2004-11-04	IEEE C802.16e-04/518				
Project	IEEE 802.16 Broadband Wireless Access Working Group < <u>http://ieee802.org/16</u> > MIMO transmission for UL FAST_FEEDBACK and Fast MIMO Feedback Channels				
Title					
Date Submitted	2004-11-04				
Source:	Wen Tong, Peiying Zhu, Ming Jia, Jianglei Ma , Dongsheng Yu, Mo-Han Fong, Hang Zhang and Brian JohnsonVoice: (613)-763-1315 Fax: (613)-765-7723				
	Nortel Networkswentong@nortelnetworks.com3500 Carling AvenueOttawa, ON. K2H 8E9CANADA				
Re:	Response to sponsor ballet				
Abstract	Enhance the UL feedback channels by space time coding				
Purpose	To incorporate the changes here proposed into the 802.16e D5 draft.				
Notice	This document has been prepared to assist IEEE 802.16. It is offered as a basis for discussion and is not binding on the contributing individual(s) or organization(s). The material in this document is subject to change in form and content after further study. The contributor(s) reserve(s) the right to add, amend or withdraw material contained herein.

## MIMO Transmission for UL FAST\_FEEDBACK and Fast MIMO Feedback Channels

Figure WWW 8.4.5.4.10.10.2 Enhanced transmit diversity Fast Feedback channel for optional PUSC

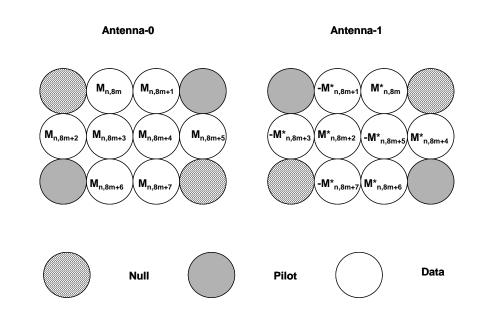
For UL MIMO enabled MSSs (MSSs with two transmit antennas), STC may be applied in the transmissions of uplink feedback channels to improve the coverage. 2xM STTD is implemented (M is the number of receive antennas at BS). With the UL tile allocation shown in figure 249a for PUSC zone, the transmission from antenna-0 is the same as in non-MIMO operation, however, the different sub-carrier mapping method is applied to antenna-1 (see figure WWW).

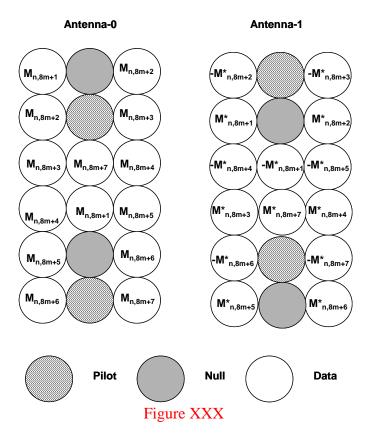
With the UL tile allocation shown in figure 252a for optional PUSC zone, two data sub-carriers should be punctured in each MIMO tile in order to obtain two extra pilot sub-carriers (same requirement for UL MIMO traffic channel). To reduce the impact from the puncturing, the first QPSK symbol (P0) in each orthogonal modulation index is removed (Table 295 and 296c) (see figure XXX). The mini subchannelization scheme described in section 8.4.6.2.4 shall be used with M=2, type = 01. CQICH channel shall be allocated simulatanously for two MSS, each uses one of the mini subchannel as specified in CQICH\_Enhanced\_Alloc\_IE().

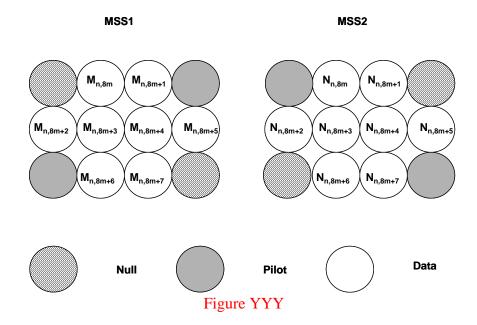
Multi-user collaborative spatial multiplexing can also be applied to uplink feedback channel to reduce the overhead introduced by the uplink feedback channels. In this case, BS assigns the same feedback channel resource to two single antenna MSSs. Each MSS selects the tile patter (pattern A or pattern B) according to the instruction from BS, and transmits the data burst independently with the same modulation and coding scheme for non-MIMO operation. Figure YYY and figure ZZZ show the mapping of the orthogonal modulation index for MSS-1 and MSS-2, where M is the orthogonal modulation index for MSS1 and N is the orthogonal modulation index for MSS2

## Figure ZZZ

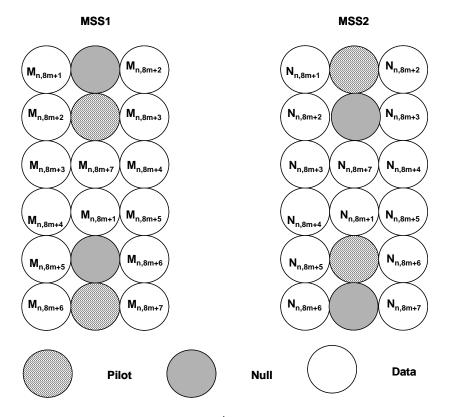
CQICH channel shall be allocated simulatanously for two MSSs, each uses one of the mini subcahnnel as specified in CQICH\_Enhanced\_Alloc\_IE(). The same physical CQICH channel resource can be allocated to another two MSSs through spatial multiplexing. The MSS shall use the pilot pattern as specified in CQICH\_Enhanced\_Alloc\_IE().
